N1092B-05

Information Only Service Note

N1092B DCA-M Sampling Oscilloscope

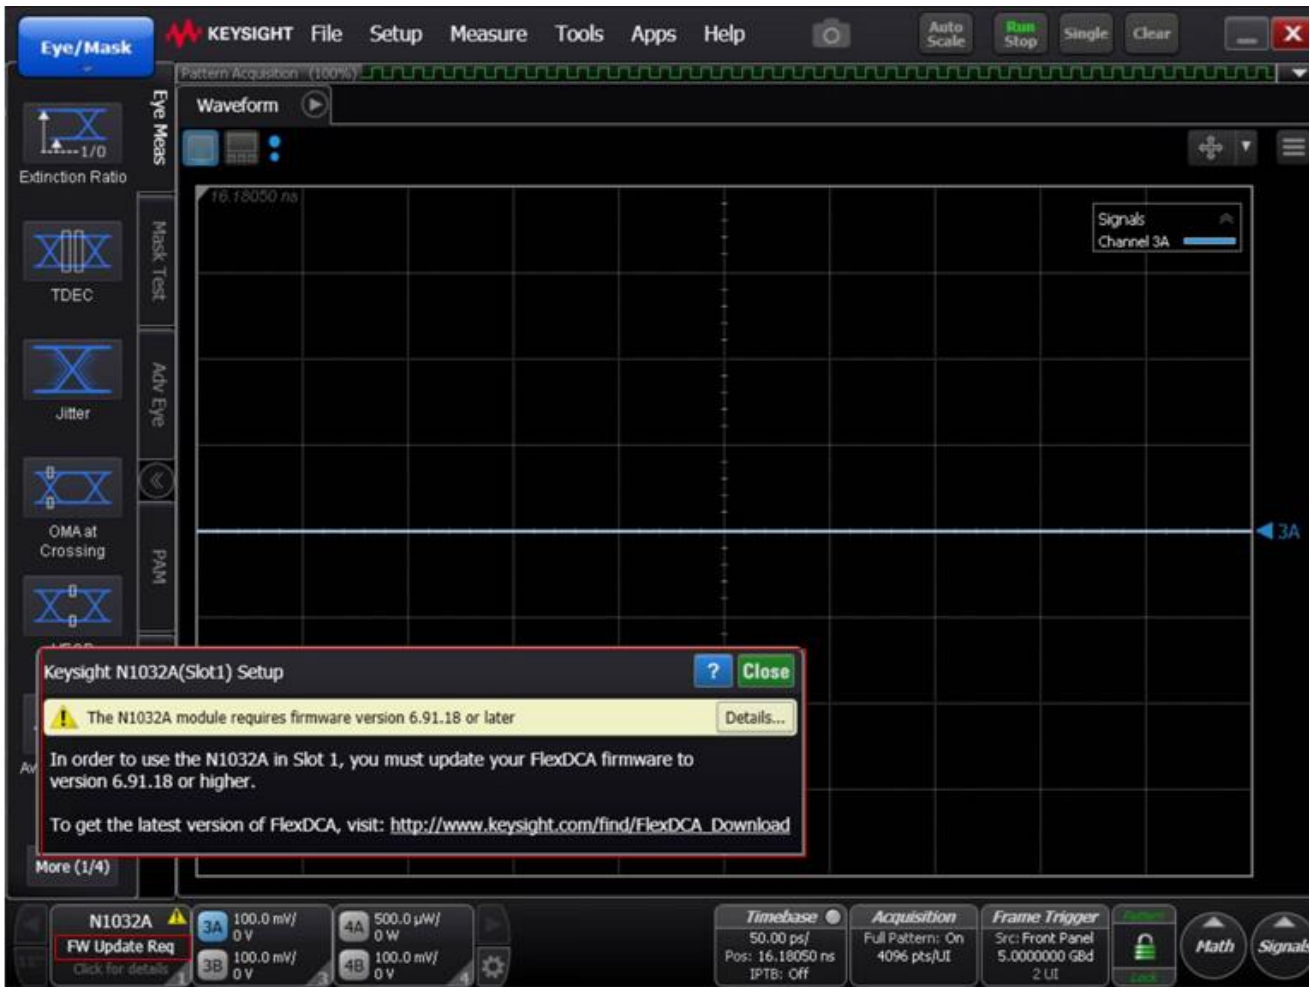
With the instrument connected to FlexDCA, if a message like the one below is displayed, FlexDCA must be updated to the indicated version (or later):

To update FlexDCA software, download from www.keysight.com/find/flexdca_download and install. While only the indicated version is required, updating to the latest version is recommended.
